Burlington Development Review Board

BURLINGTON DEVELOPMENT REVIEW BOARD

MEMORANDUM

To: Development Review Board
From: Mary O'Neil, AICP, Principal Planner
Date: ~~April 21, 2020~~ June 16, 2020
RE: ZP20-0773CU, 10 Baird Street

0	12/30/19	Final Design	
NW Elev. (West Wall)			DWG. NO.
EXCAVATION SHEETING			SH
110 RIVERSIDE AVE.			
HOUSING			PROJ. NO.
BURLINGTON, VT			
			19239
	KNIGHT CONSULTING ENGINEERS, INC.		DATE: 09/06/20
	183 COMMERCE STREET, WILLISTON, VT., 05495 - TEL. 879-6343		SCALE: NOTE

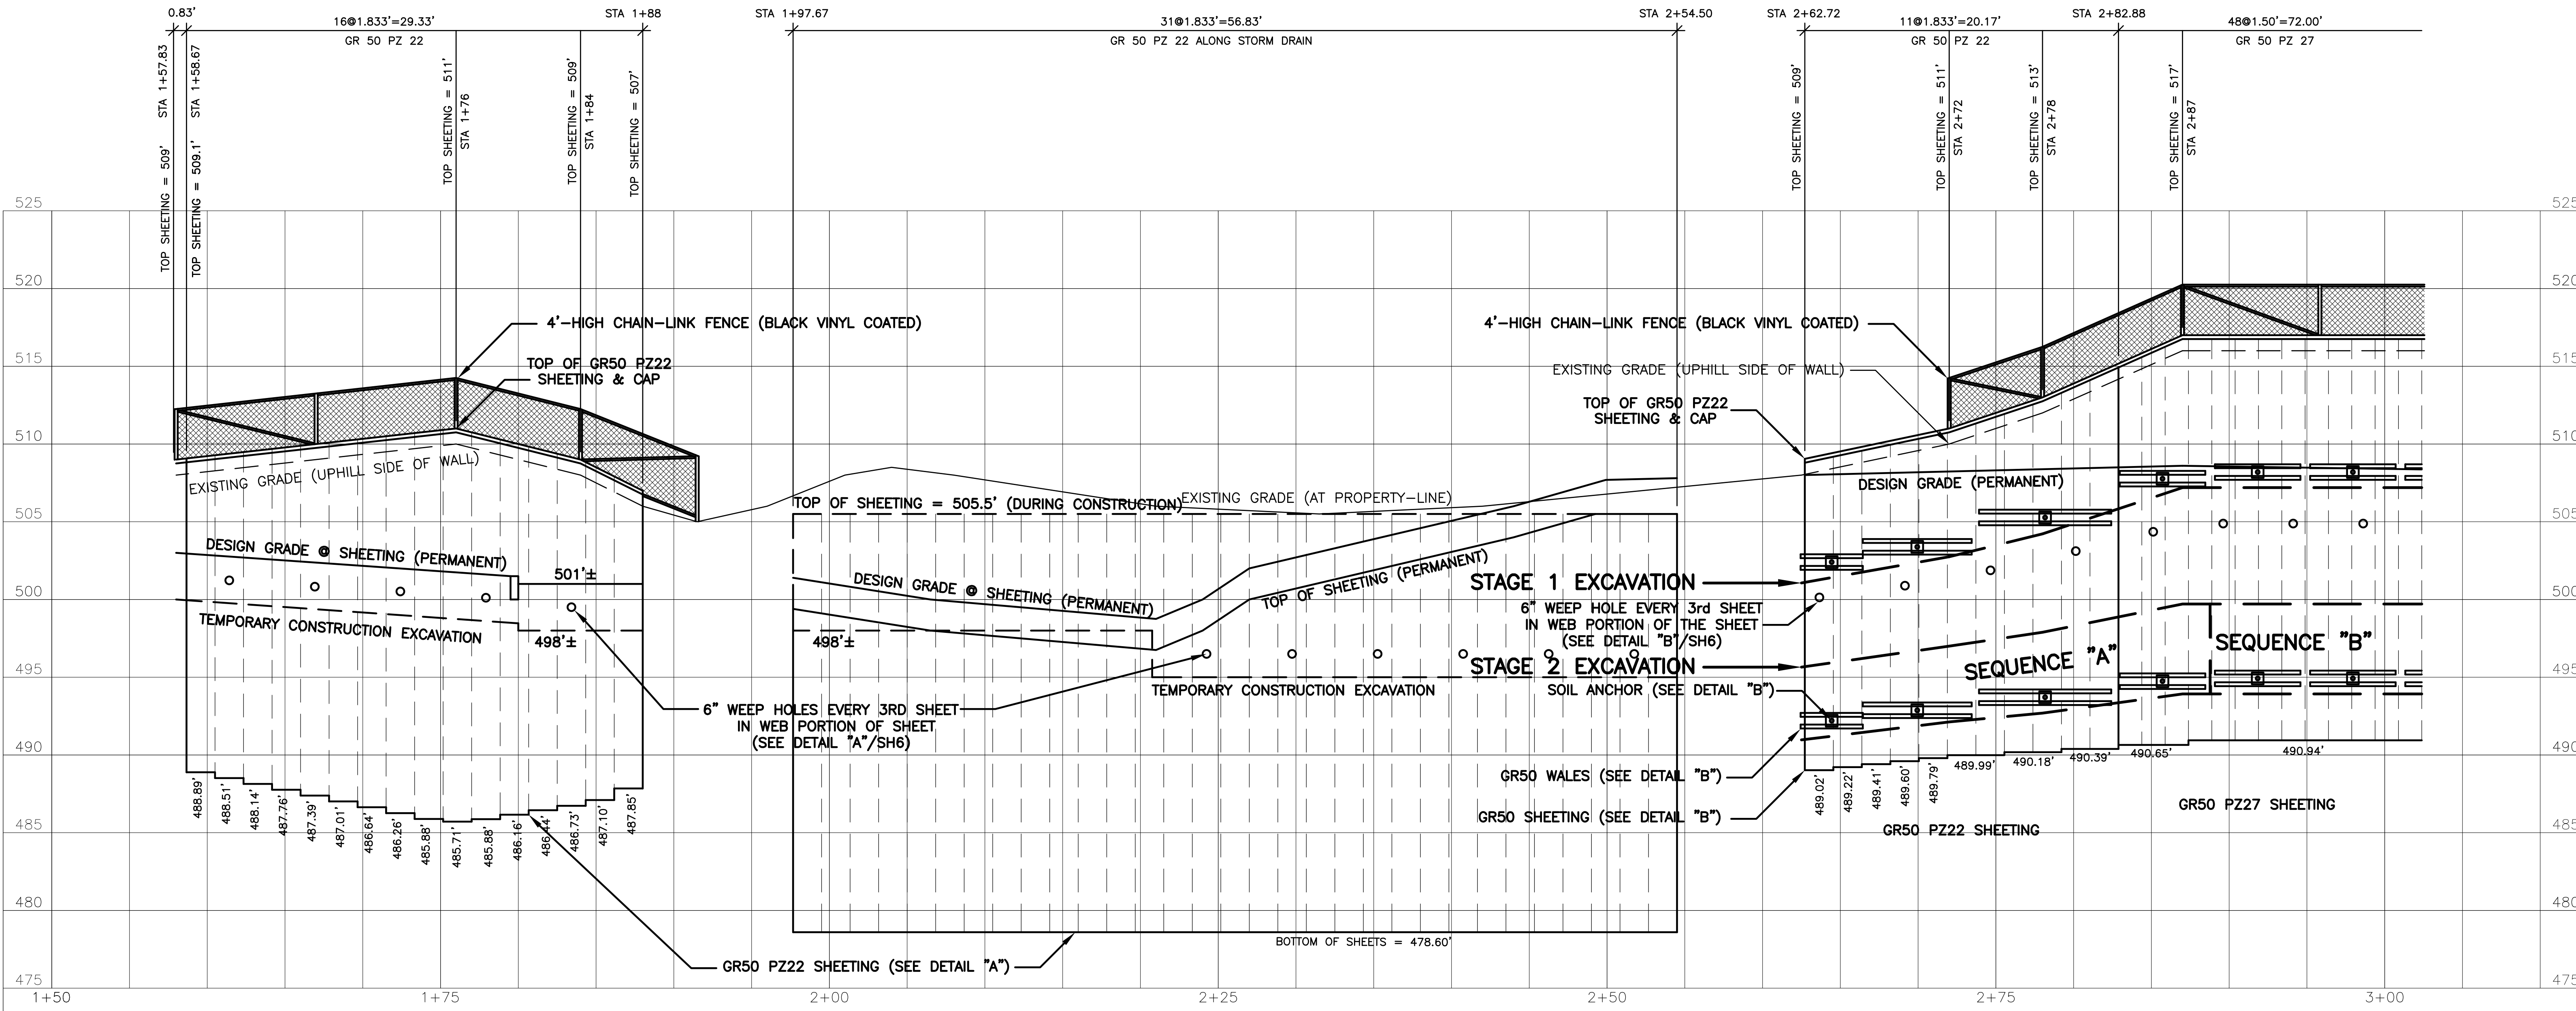
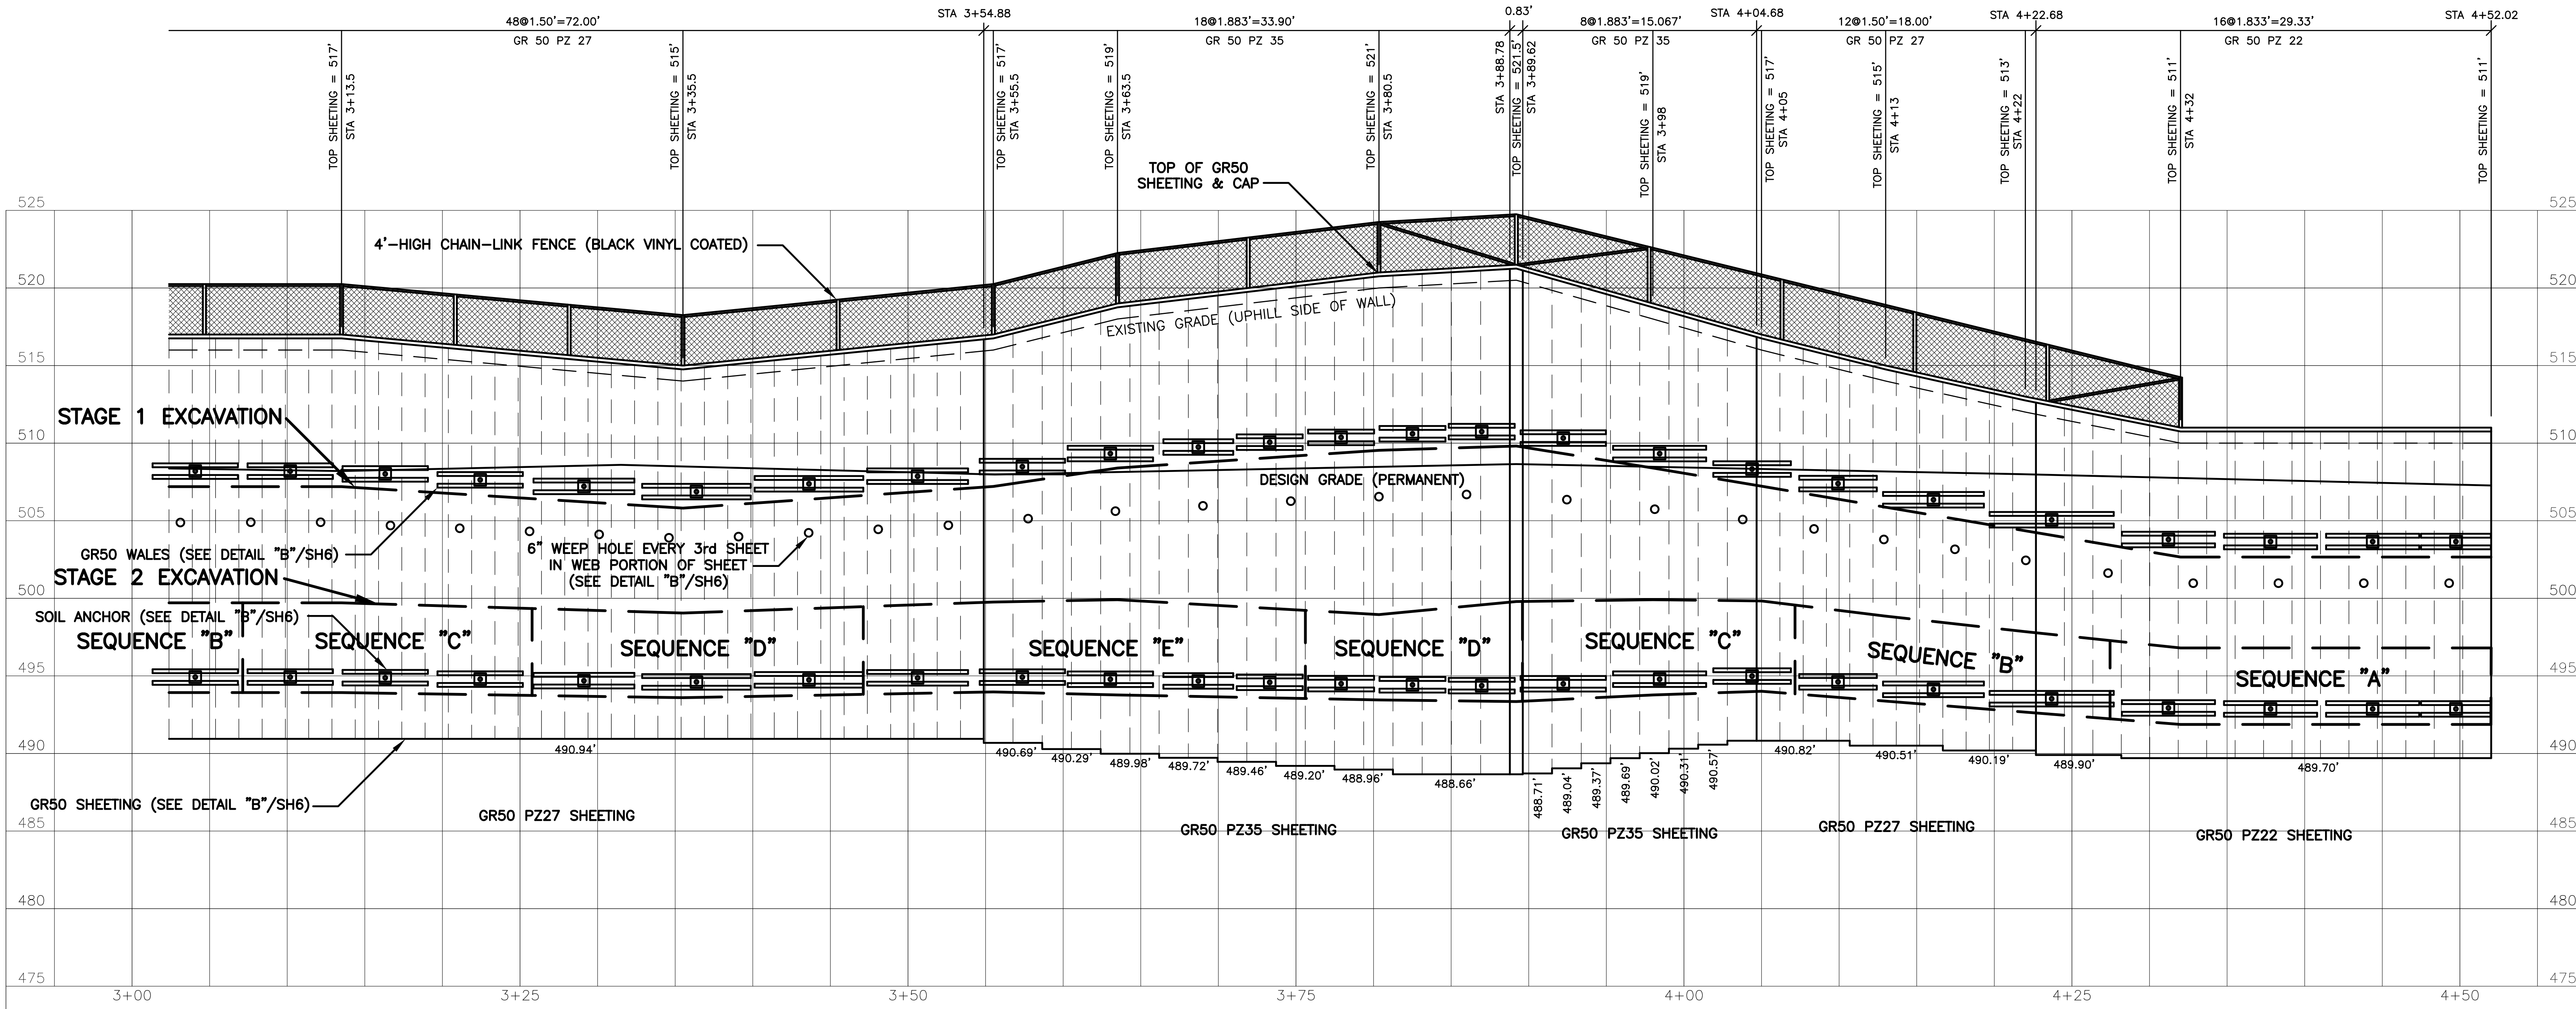
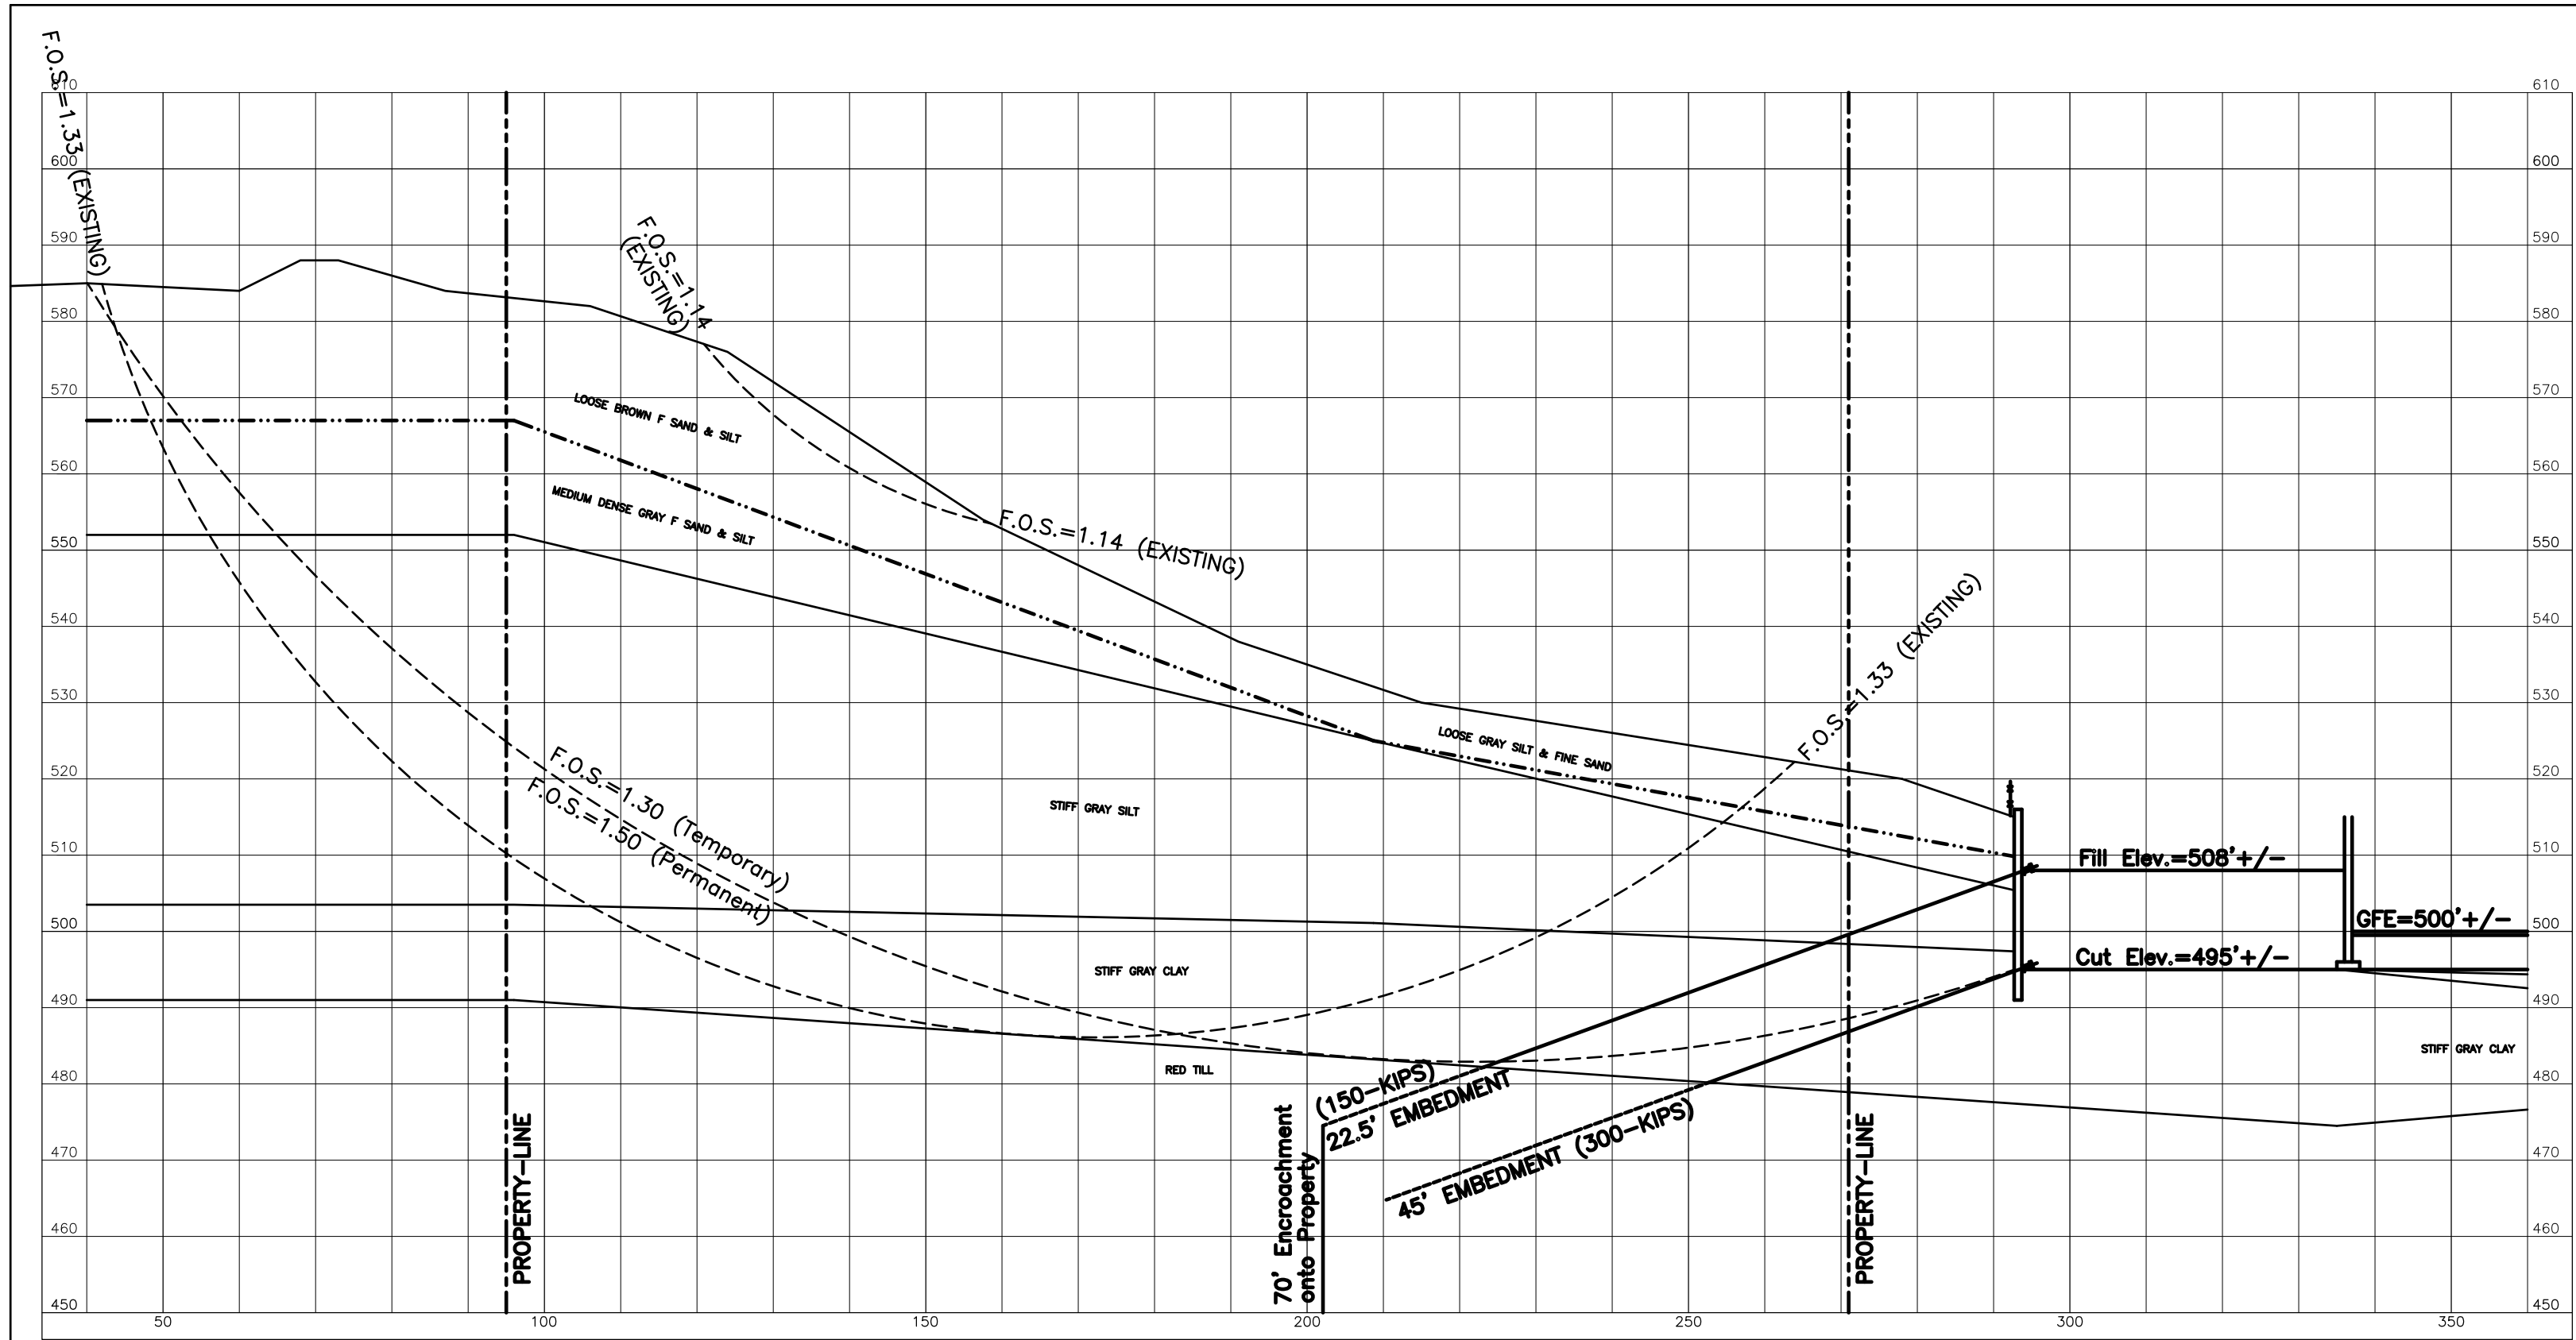
As required, geotechnical details have been provided as to the proposed retaining walls behind the building. Significant cut into the bank is proposed. Sheet piling will hold back the bank to allow space for the building and related parking. Site plan details, elevations, cross sections, and anchoring details have been provided. All have been provided by a Vermont licensed engineer. The City Engineer has reviewed the shoring plans and has identified only one remaining issue as to property rights to install and maintain the retaining wall system with neighboring properties. A draft easement with the adjoining property for anchoring and maintaining the proposed retaining wall has been submitted for review. The applicant requests that execution of the easement be a condition of approval. **Affirmative finding as conditioned.**
